**KOLKATA PORT TRUST**

**HALDIA DOCK COMPLEX**

**E-Tender under two cover system (Cover-I: Pre-qualification, Techno-commercial terms and Cover-II: Price cover) for work of “Design, Manufacture, Fabrication, Supply, Erection, Testing, Commissioning and handing over of firefighting facilities at 3rd Oil Jetty (HOJ-III) under two cover systems.”**

**♠ ADDENDUM-II ♠**

## **TOWER MONITOR FOR FIRE FIGHTING SYSTEM AT HOJ-III OF HDC AS PER OISD-156.**

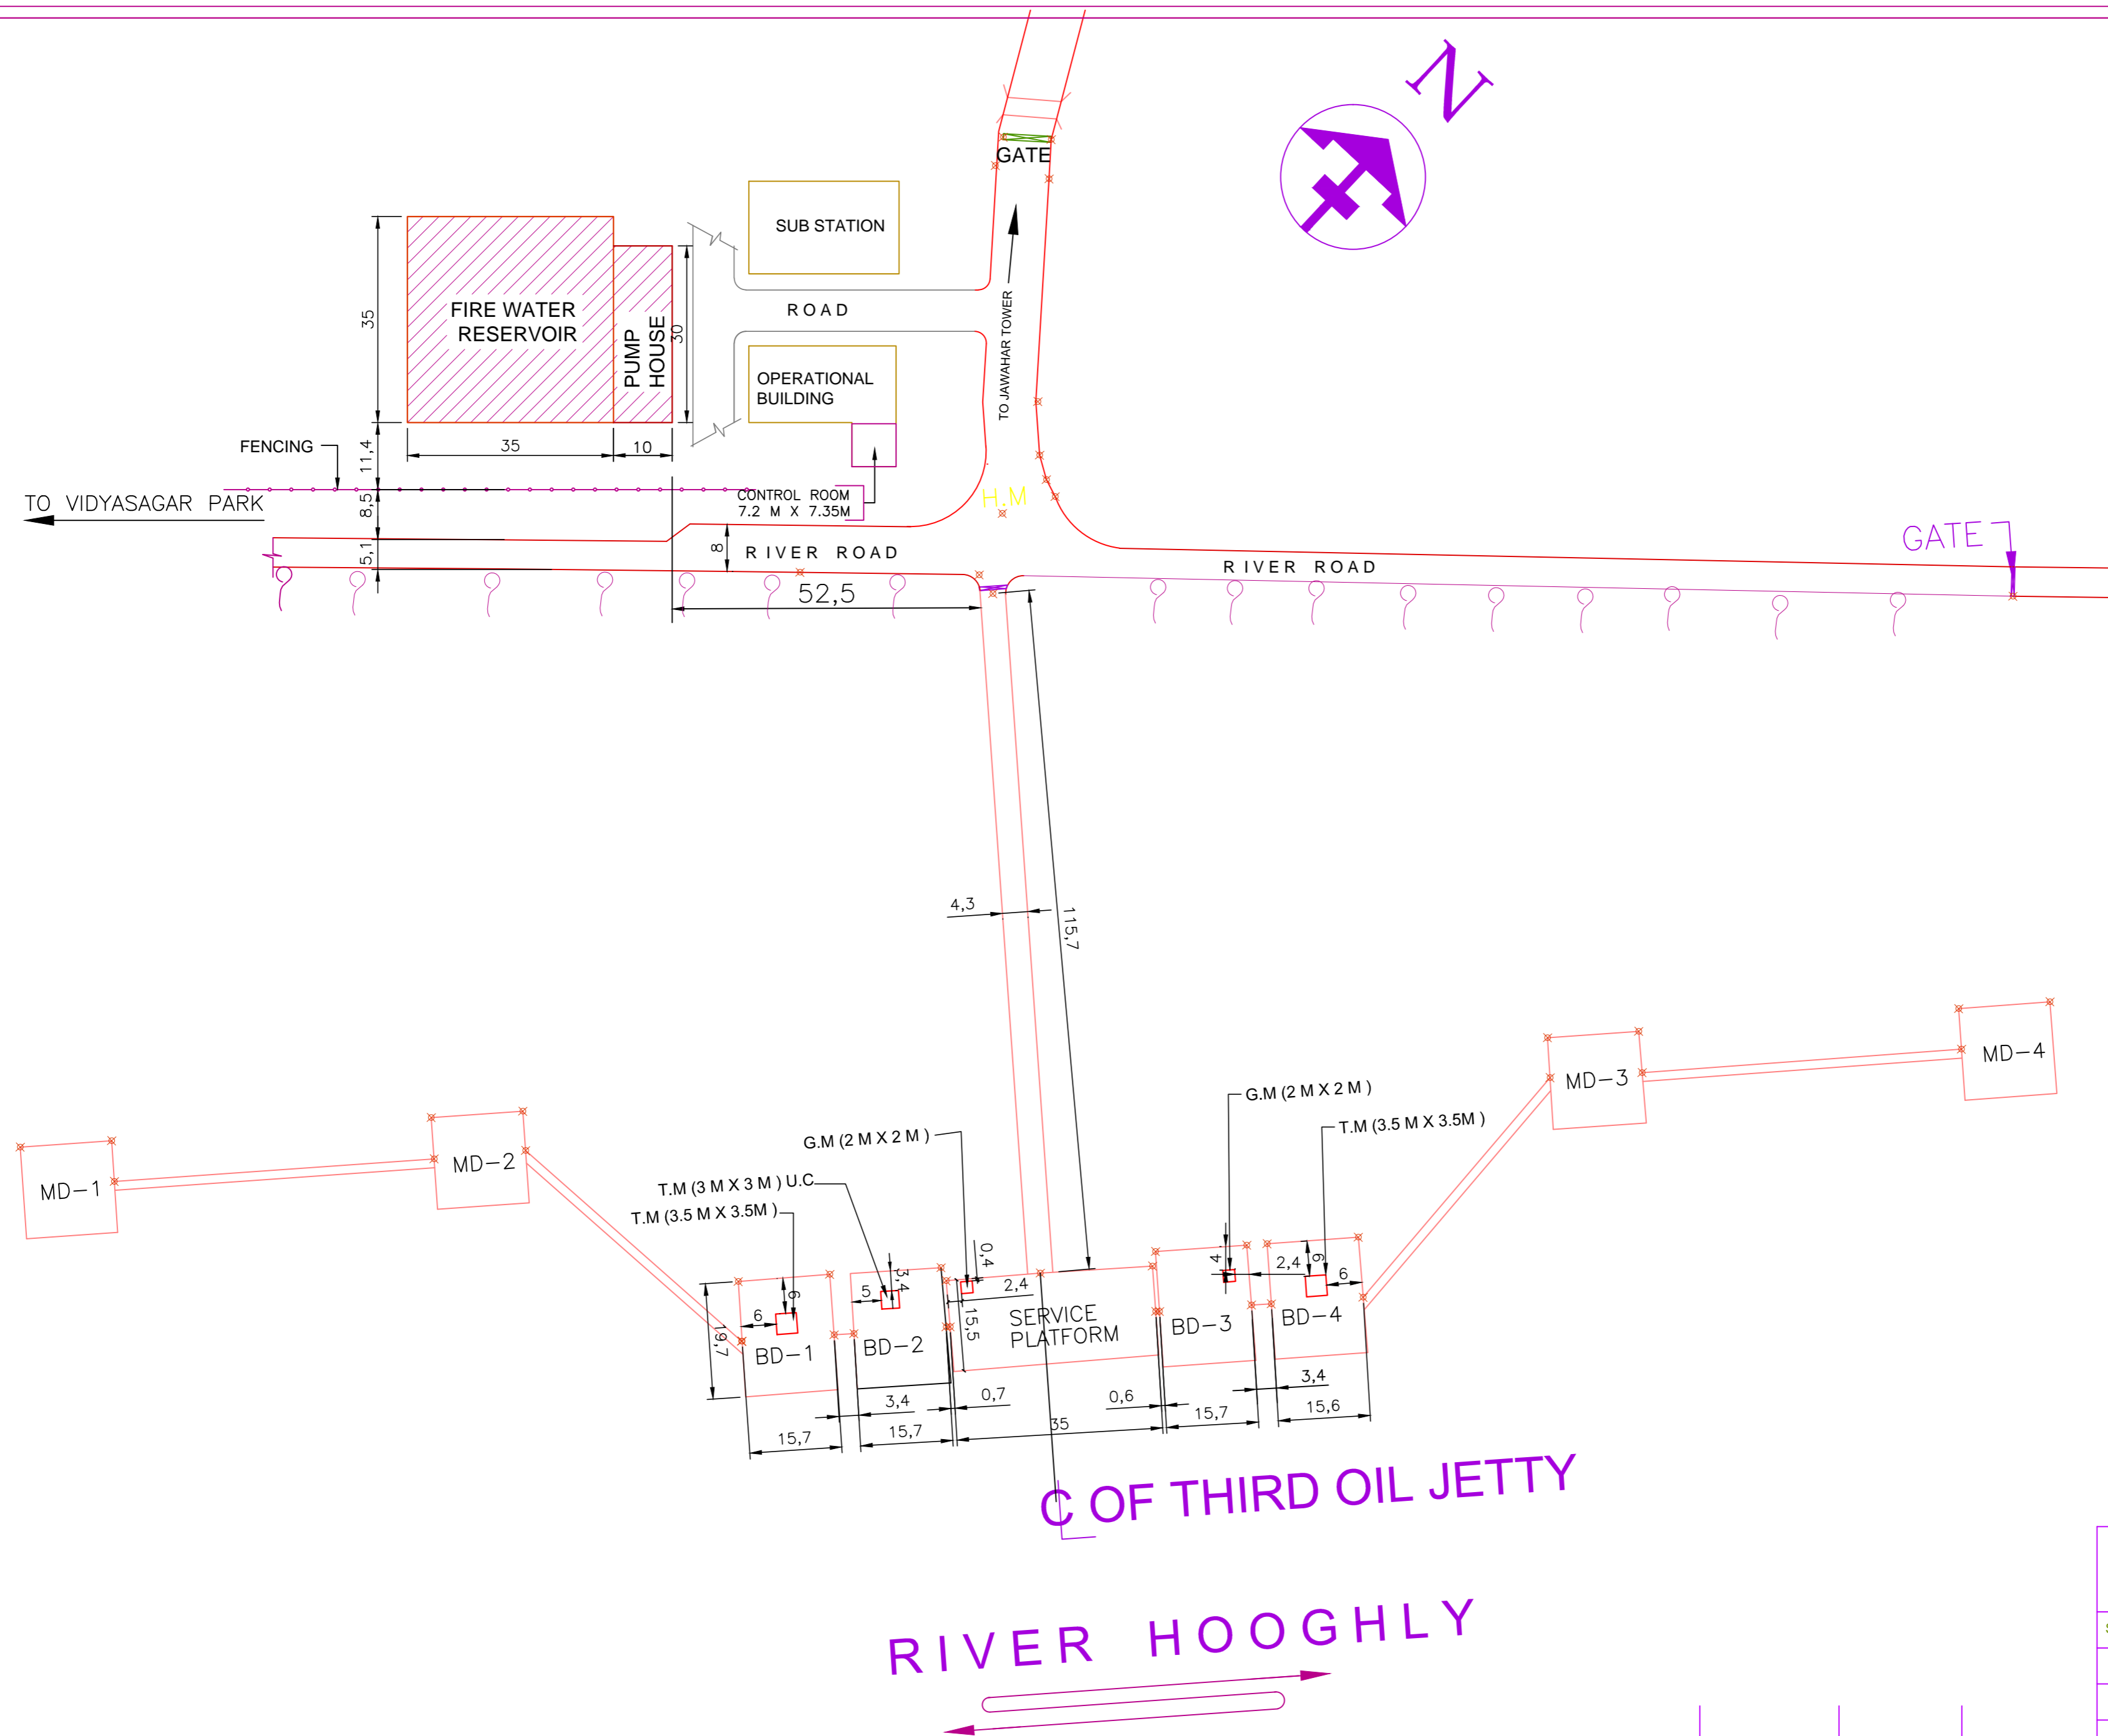
1.	.....	.....	.....	The tentative P&I diagram of the system is enclosed at page no- 11 of this addendum.
2.	BoQ Sl.no. 3	238		Tentative structural drawing of Tower Monitor-II is provided at Pg no. 12&13 of this Addendum.

Vertical column up to 7.75 m –Star L 100x100x10  
Vertical column above 7.75 m – L 100x100x10  
Horizontal Tie Beam – ISMC 100  
Bracing up to 6.2m – L 100x100x10  
Bracing from 6.2m to 12.4m – L 90x90x8  
Bracing above 12.4m – L 75x75x8  
Pipe supporting angle – L80x80x10

However, the bidder has to design the structure of Tower Monitor conforming to OISD-156.
